**Number: SB2X-25-31R1****Issued: 12 Aug 2024****Revised: 08 Dec 2025**

**SNS SUBJECT: 25-10 CABIN - Secondary Seat Latch and Stop**

This service bulletin has been revised to update Warranty Information and Accomplishment Instructions. Operators who have successfully complied with the original release of this service bulletin, dated 12 Aug 2024, need take no further action.

**Figure 01**  
**Seat Latch**

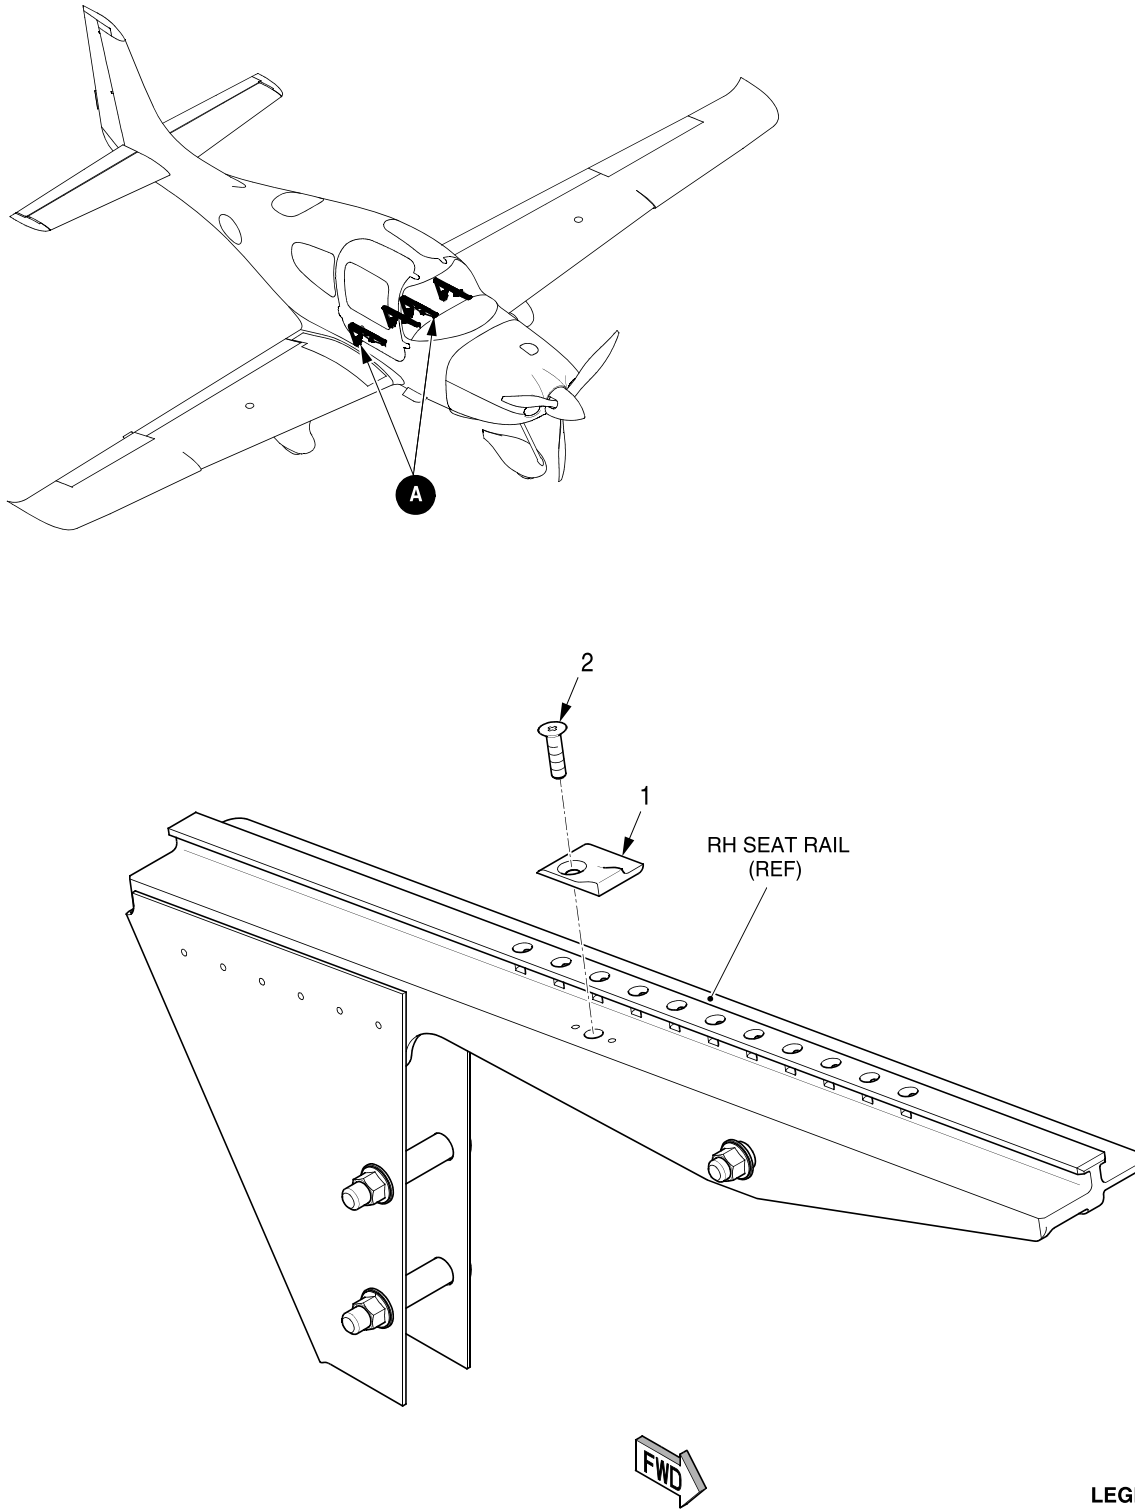
F. On inboard side of pilot's seat, install seat latch. (See Figure 01)

- (1) At center slot of lower seat frame, remove nut, washer, and screw securing forward attach point of tracking control handle to lower seat frame. Discard nut, washers, and screw.
- (2) At forward track clamps, remove and discard aft nut, washers, and bolt securing forward track clamps to lower seat frame.
- (3) At forward track clamps, remove and discard center-forward nut, washers, and bolt securing roller bearing to forward track clamps.

- (4) Assemble seat latch.
  - (a) Insert spring (item 10) and pass-through hole end of pin (item 9) into cavity of housing (item 7).
  - (b) Compress pin and spring so that pass-through hole of pin is visible in opening at front side of housing.

- (c) At back side of housing, insert arm (item 8) pegs into pass-through holes of housing and pin.
  - (d) Ensure arm pegs are retained and pin compresses as expected.
- (5) Position arm of seat latch assembly to forward track clamps.
- (6) At center-forward hole of forward track clamps, secure seat latch assembly and roller bearing to forward track clamps with bolt (item 5), washers (item 3) (item 12), and nut (item 4).
- (7) At aft hole of forward track clamps, secure seat latch assembly and forward track clamps to lower seat frame with bolt (item 5), washers (item 3) (item 12), and nut (item 4).

- (8) Depress crew seat pin and spring as required to allow for installation of screw at cut-out portion of crew seat pin.

- (9) At center slot of lower seat frame, secure seat latch assembly and forward attach point of tracking control handle to lower seat frame with screw (item 11), washers (item 3) (item 6), and nut (item 4).
